# City of Santa Fe, New Mexico

# memo

2025-011459-HDRB, 912 Don Gaspar Ave, Don Gaspar Area Historic District, significant, Positive Energy Solar, agent for Moe Zamora, owner, proposes to install publicly visible solar. Exceptions are requested to section 14-5.2(D)(3)(b) for publicly visible rooftop appurtenances and 14-5.2(D)(5)(b) for placing features on a primary facade.

Figure 4: Site Plan location of panels

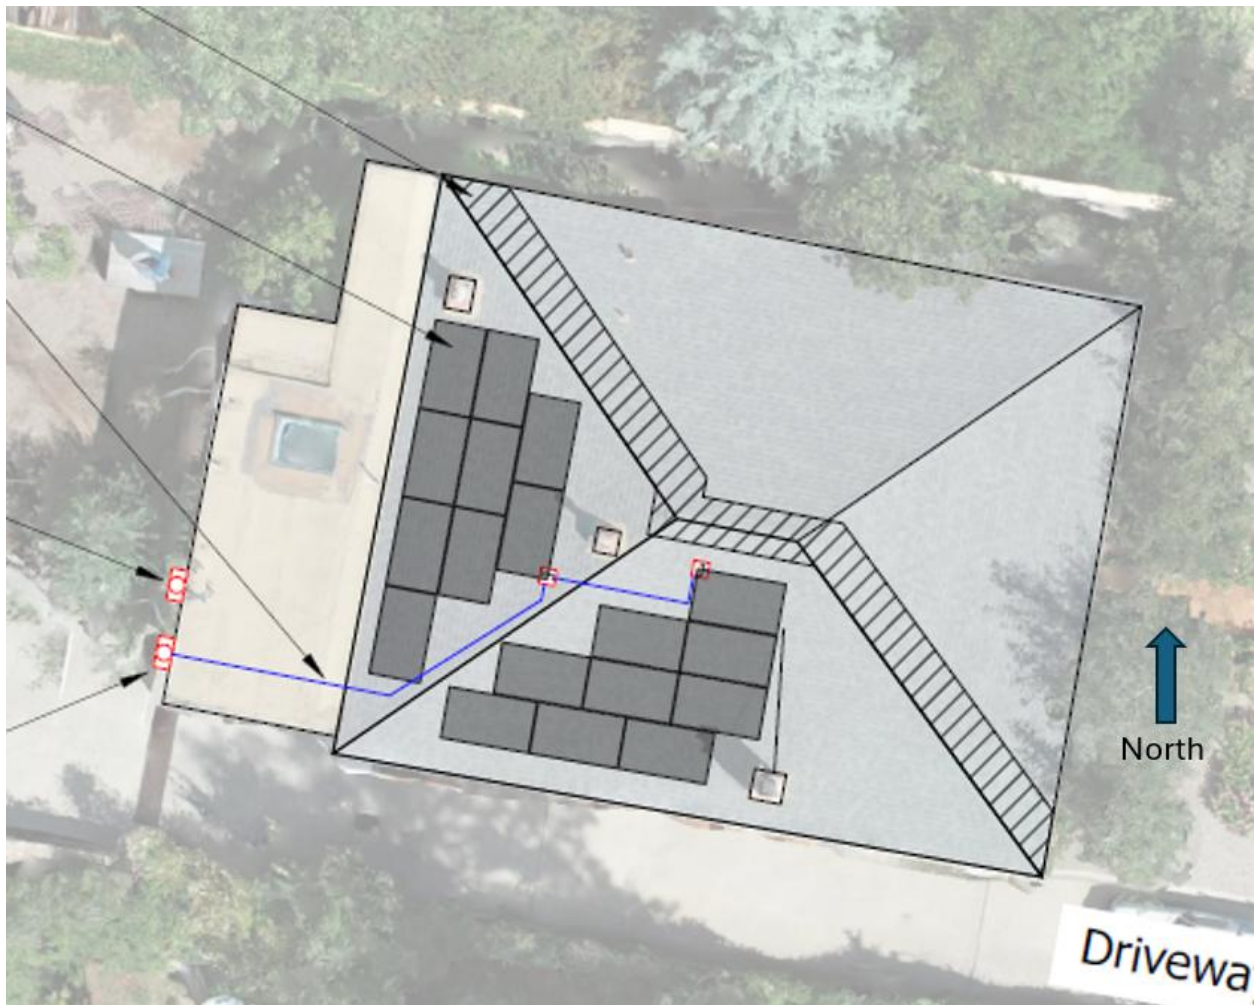
1. Install publicly visible solar on a primary façade. The panels will be flat against the pitch of the roof. Nine panels will be installed on the west elevation roof, and nine panels will be installed on the south elevation roof. The west elevation is the rear of the house and will be publicly visible from West Houghton Street. The south elevation is publicly visible from Don Gaspar Avenue. Don Gaspar Avenue is one-way going south, so the vehicle traffic will not immediately see the panels; however, pedestrians will be able to see the array. The proposed solar panels on the south elevation have been setback from the front of the building to mitigate the impact on the streetscape. Exceptions are requested to section 14-5.2(D)(3)(b) for publicly visible rooftop appurtenances and section 14-5.2(D)(5)(b) for placing features on a primary façade.

Staff Response: Staff finds that this criterion is not met. While vehicle traffic may not see the panels due to the direction of the one-way street, pedestrians are able to circulate both north and south and will be able to see the panels on the south elevation from Don Gaspar Avenue. They will be able to travel east and west on West Houghton Street, where the west elevation panels will be publicly visible. Foliage is not considered screening as it can be removed, though staff recognizes that the west elevation array will not be publicly visible. While the solar panels are integrated into the pitch as required by section 14-5.2(H)(1)(c)(iv) for the Don Gaspar Historic District, this particular property is a significant structure, and publicly visible solar is not allowed because it will detract from the significant building and the district.

Staff Response: Staff finds that this criterion is met. Other design options have been considered and do not provide for the needs of the homeowner. The west elevation panels are not publicly visible and could be considered, but the south elevations are publicly visible and as minimally visible as possible with a pitched roof. Solar panels are encouraged in the Don Gaspar Area Historic District, and these solar panels are integrated into the pitch as required by section 14-5.2(H)(1)(c)(iv) for the Don Gaspar Historic District.

Staff Response: Staff finds that this criterion is not met. This addresses public visibility, but does not place the solar on a primary facade. While the solar panels are integrated into the pitch as required by section 14-5.2(H)(1)(c)(iv) for the Don Gaspar Historic District, this particular

Staff Response: Staff finds that this criterion is not met. The applicant has not shown that there is a hardship sufficient for solar panels on the primary façade of a significant structure.

Staff Response: Staff finds that this criterion is not met. The applicant has offered a range of options for other locations, including the possibility of a pole-mounted or ground-mounted option. However, it does not address the fact that the roofs of the residence are primary facades of a significant structure.

Staff finds that the exception criteria to section 14-5.2(D)(3)(b) have not been met and recommends denial for publicly visible rooftop appurtenances, and the exception criteria to section 14-5.2(D)(5)(b) have not been met and recommends denial for placing features on a primary facade. Staff recommends denial of the application as it does not comply with 14-5.2(D) General Design Standards for all Historic Districts, and 14-5.2(H) Don Gaspar Area Historic District Design Standards.
